CITY OF GLENDALE, CALIFORNIA

**RE: 350 MYRTLE STREET  
ADMINISTRATIVE DESIGN REVIEW CASE NO. PDR 1913994**

**City of Glendale  
Community Development Department  
Design Review Staff Report – Multi-Family**

**1 SITE AND FIRST FLOOR PLAN**  
 SCALE 1/8"=1'-0"

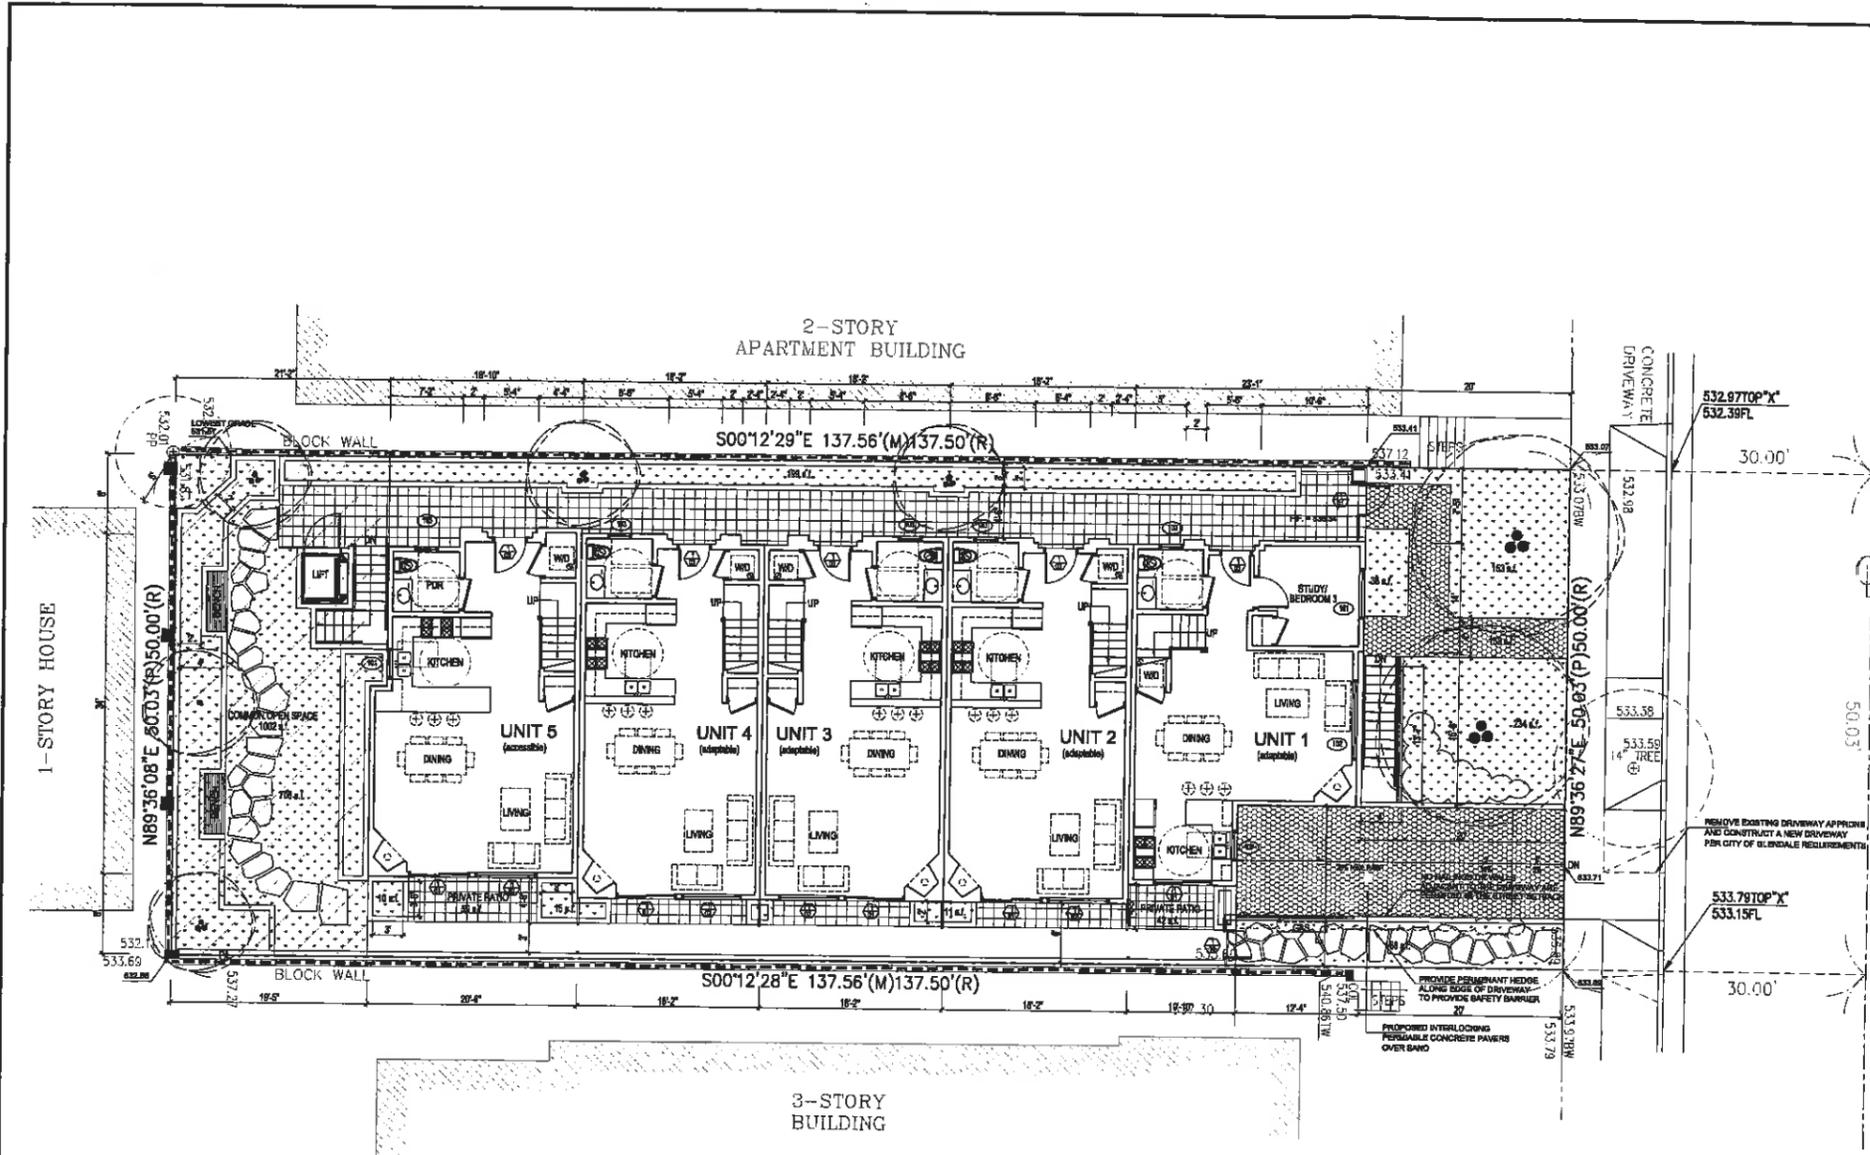
The proposed landscape plan is complementary to the building design and includes drought tolerant landscaping. However, a condition of approval is added requiring to add three (3) additional trees within the proposed planter area along the west property line.

- The proposed landscape plan is complementary to the building design and includes drought tolerant landscaping. However, a condition of approval is added requiring to add three (3) additional trees within the proposed planter area along the west property line.
- The proposed perimeter wall is complementary to the design concept with an appropriate set back from the front property line and consists of 3'-6" high concrete wall with cement plaster finish with 3'-0" high metal fence above it.
- The proposed rooftop equipment is appropriately integrated into the design and adequately screened from public view.
- The trash bins and recycling containers are located in the new semi-subterranean garage and are not visible from the street.
- The proposed light fixtures are appropriately located adjacent to the main entries and patio doors.

1. Add three (3) additional trees within the proposed planter area along the west property line.
